State Significant Development Application – SSD 9694, 301 and 305 Kent  
Street, and 35–39 Erskine Street, Sydney

# Response to Submissions Addendum

Figure 1 - Stage 1 DA proposed building envelope (Erskine Street / North Elevation)

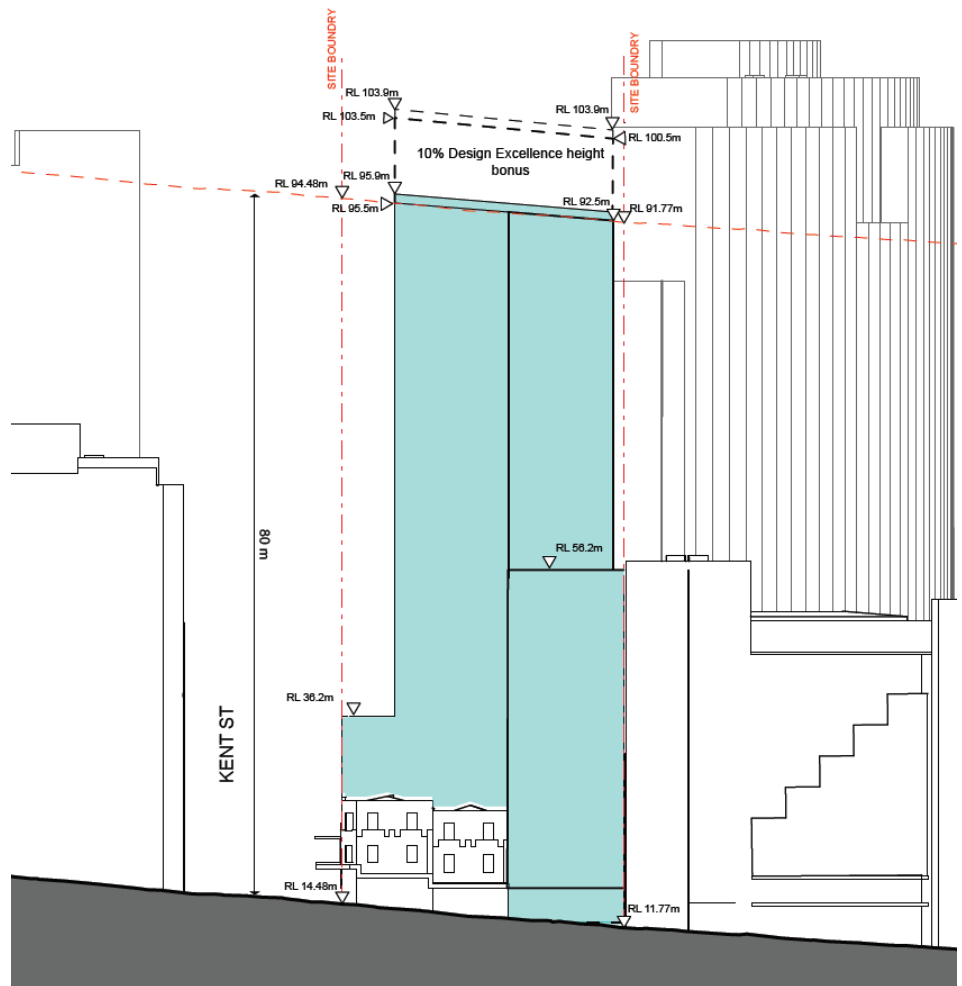
The City of Sydney Council's response to the response of submissions, provided that the Council did not support the 5.6% variation to the height control. They requested the building envelope drawings are to be amended to reflect the 80m height limit that aligns with the topographical fall of the site.

The Clause 4.6 variation to Building Height development standard is withdrawn, and a Concept Envelope is proposed that complies with the maximum LEP building height control of 80m. The highest point of the proposed Concept Envelope will be RL 95.9m on the south-east elevation.

Additional building height or FSR of up to 10% shown on LEP building heights / FSR maps respectively, may be sought in a future design competition, where it is demonstrated the design exhibits design excellence. This would then be confirmed in a Stage 2 Detailed DA. The amended Concept Architectural plans show 10% height bonus.

This plan shows the proposed concept envelope (shaded in blue). The highest point of the proposed Concept Envelope will be RL 95.9m on the south-east elevation. The plan also shows the potential additional 10% Design Excellence bonus height (dotted line).

**Figure 2 – Revised tower setbacks**

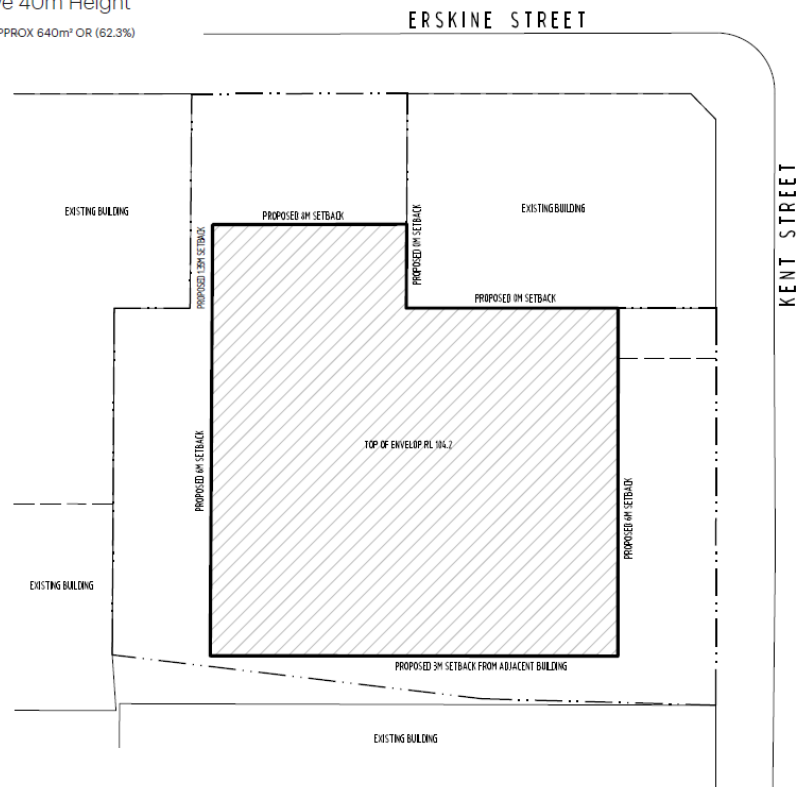
The City of Sydney raised issues with the proposed setbacks of the building. The proposal is consistent with SDCP 2012 5.1.2 Building Setbacks and ensures the objectives of SLEP 2012 6.16 Erection of tall buildings are met.

To the North, Council require an 8m setback to the building to alleviate wind impacts.

As noted in the submission, Council require a 3m setback.

To the south, Council submitted the southern setback requirement of 3m to the boundary, however this will result in bad planning outcomes. Due to the irregularity of the site and the angled side boundary, this proposal acknowledges Council's submission however requests the 3m setback to the adjoining building.

This setback has been amended in accordance with Council's requirement, and is shown in the amended building envelope drawings at **Appendix A**.

Despite the above, the plans have been updated to allow a 1.35m setback to the adjoining western building, to accommodate for potential redevelopment if future development were to occur at 35-39 Erskine Street.

The 3m setback to the adjoining building will allow for regular built form and for the site to be parallel with the Dexus building at 209 Kent Street. The proposal provides a setback compliant with Section 5.1.2.2, subclause (3) of the Sydney DCP, mentioned above, which allows a nil setback for commercial buildings with no windows. Further, the submission from Dexus also notes that the setback to the south is compliant.

Amended architectural plans of tower show proposed 8m setback to the north, 6m setback to the west, 3m setback to the south and 6m setback to the east.
